Planning Application No. A/YL-SK/430 - Submission of Further Information

Application for Permission under Section 16 of the Town Planning Ordinance (Cap.131) Proposed Temporary Public Vehicle Park (excluding container vehicle) and Associated Filling of Land for a Period of 3 Years at

> Lots 1054 S.B and 1056 S.B (Part) in D.D. 106, Shek Kong, Yuen Long, New Territories (Planning Application No. A/YL-SK/430)

Submission of Further Information

drawing no. PLAN 1

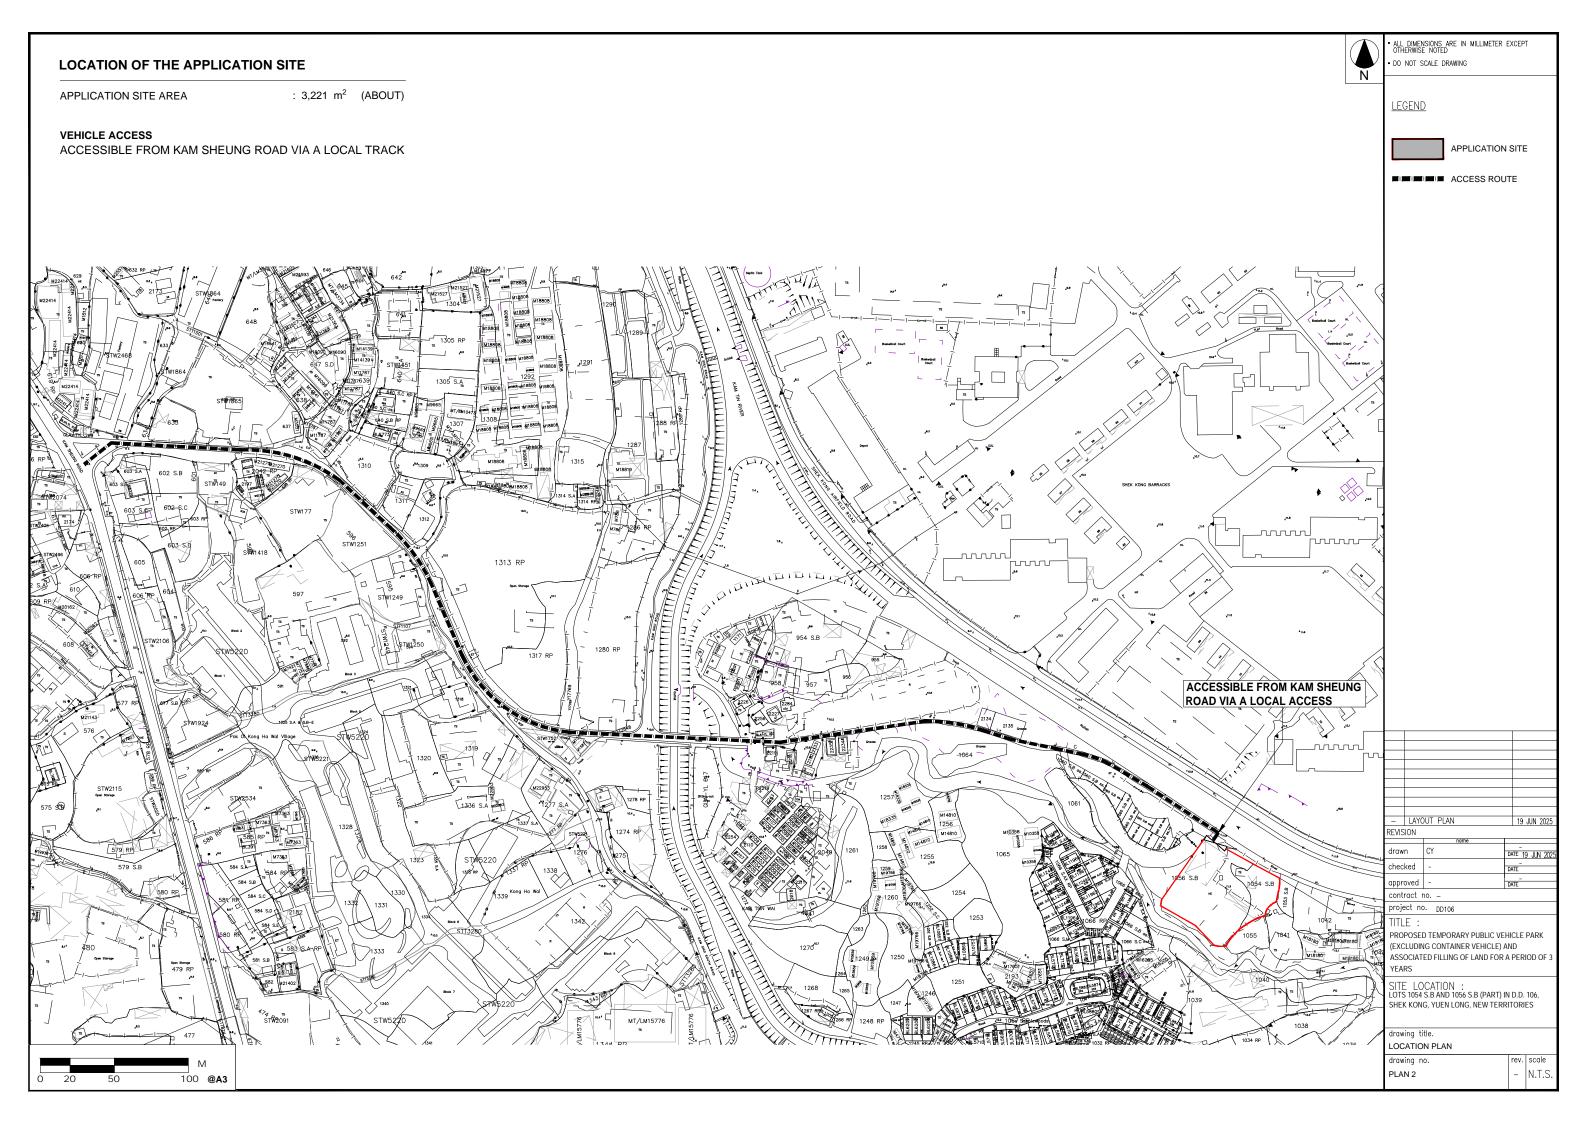
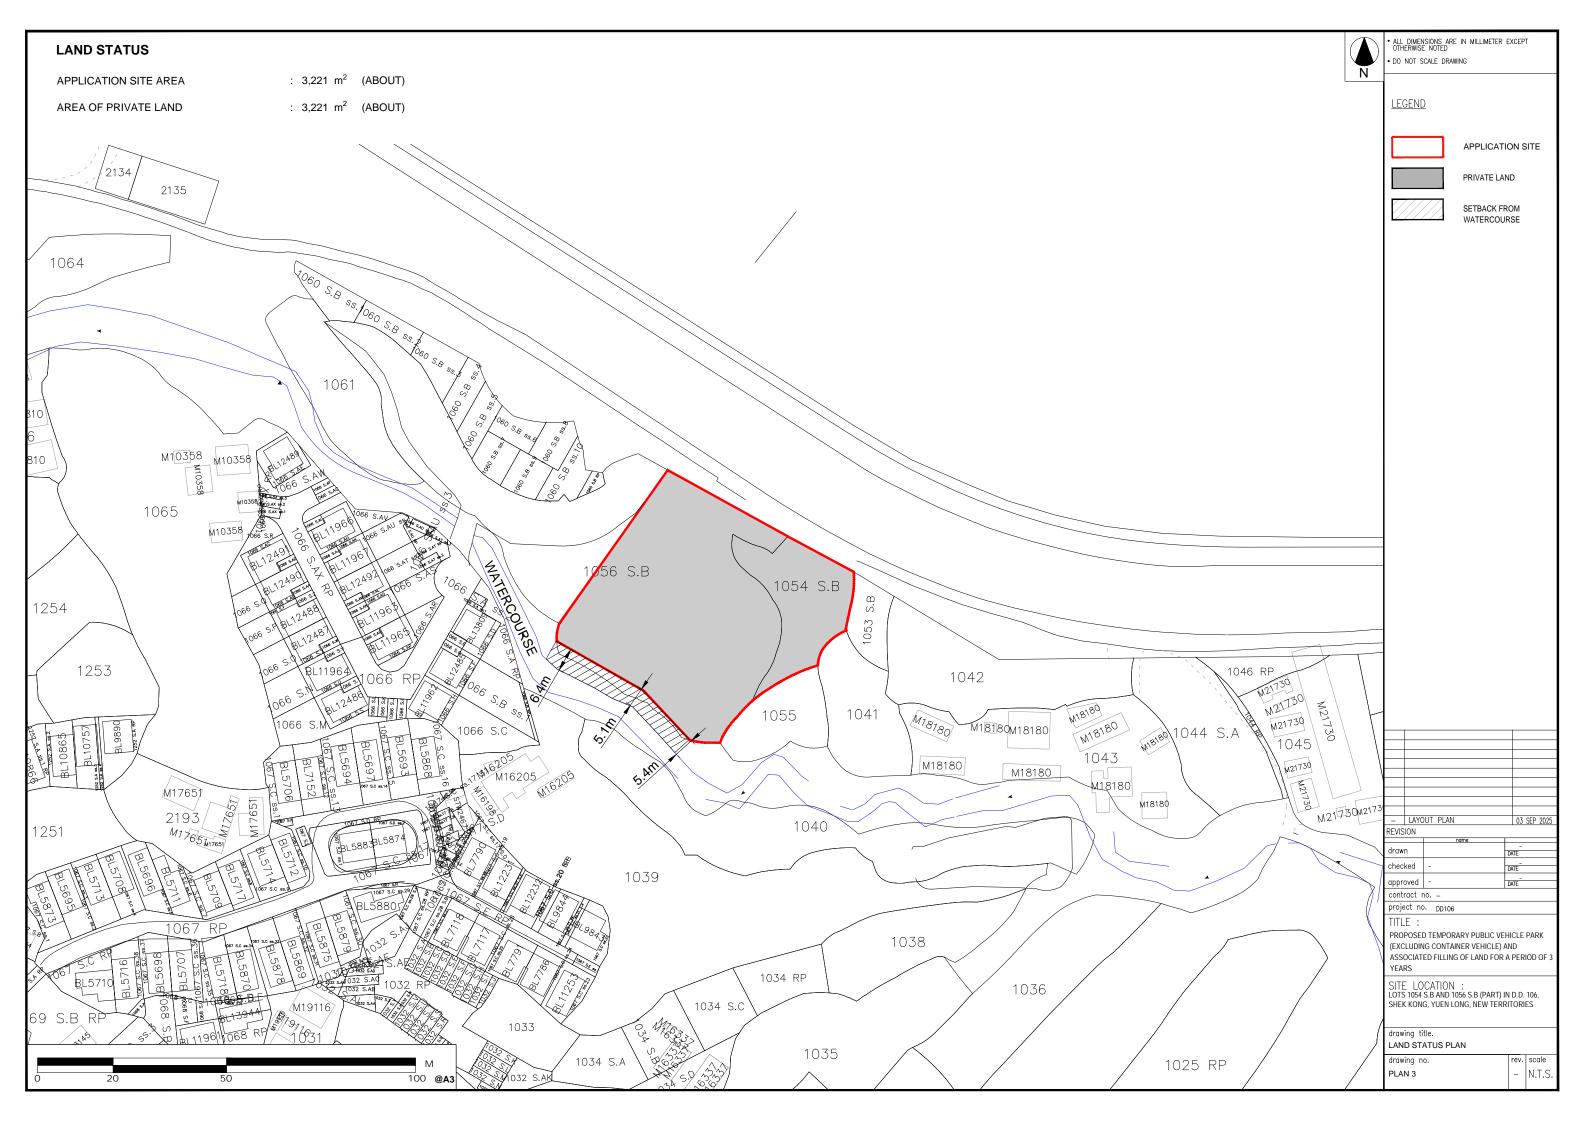
(a) There are existing streamcourse/channel on government land in the adjacent of application site. Drainage reserve is required for operation and maintenance of the streamcourse/channel. Therefore, I would recommend the application site to exclude the Government Land from the captioned S.16 application.	The application boundary has been revised to exclude the Government Land and to maintain about 5m setback from the watercourse. Please refer to Appendix III for the revised plans.

(b) In addition, the applicant shall be required to place all proposed works 3m away from the top of the bank of the impacts, both during and after construction.	The revised site boundary has taken the 3m distance from the top of the back of the impacts into consideration. The applicant will place all proposed works during and after construction beyond the said distance.

PROPOSED DRAINAGE PLAN

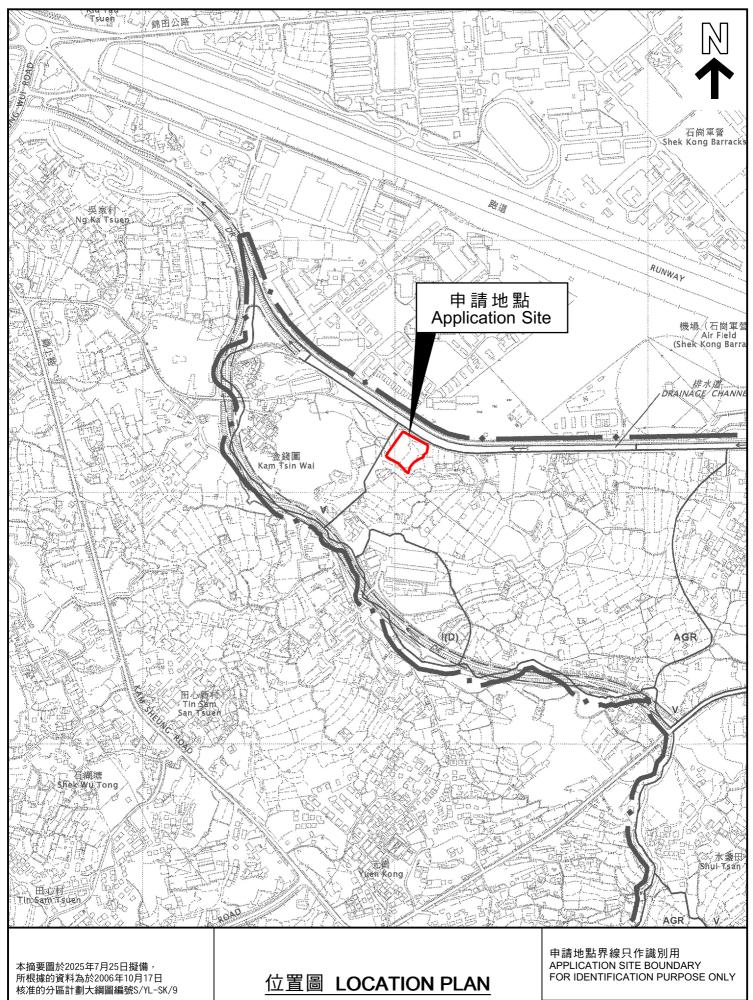
(c) We are unable to provide comment on the drainage aspect of the application at this stage. Comment on drainage aspect will be provided when the drainage proposal is received.	A drainage proposal (Appendix IV) has been prepared to demonstrate that with the implementation of the proposed drainage facilities, no significant drainage impact from the proposed development is anticipated.

The details of the proposed drainage works are illustrated in **Appendix C**.

To effectively convey stormwater away from the application site and minimize the potential impact to the drainage infrastructure of the village area, drainage works consists of U-channels, are proposed to convey the stormwater runoff to the terminate catchpit with sand trap (TCP), and finally convey to the existing catchpit.

The runoff within application site is collected by two 375mm U-channels along the boundary and convey to the existing terminate catchpit with sand trap (TCP) within the application site, before discharging to the existing catchpit at the South direction of the application site, and eventually discharge to the further downstream village drain.
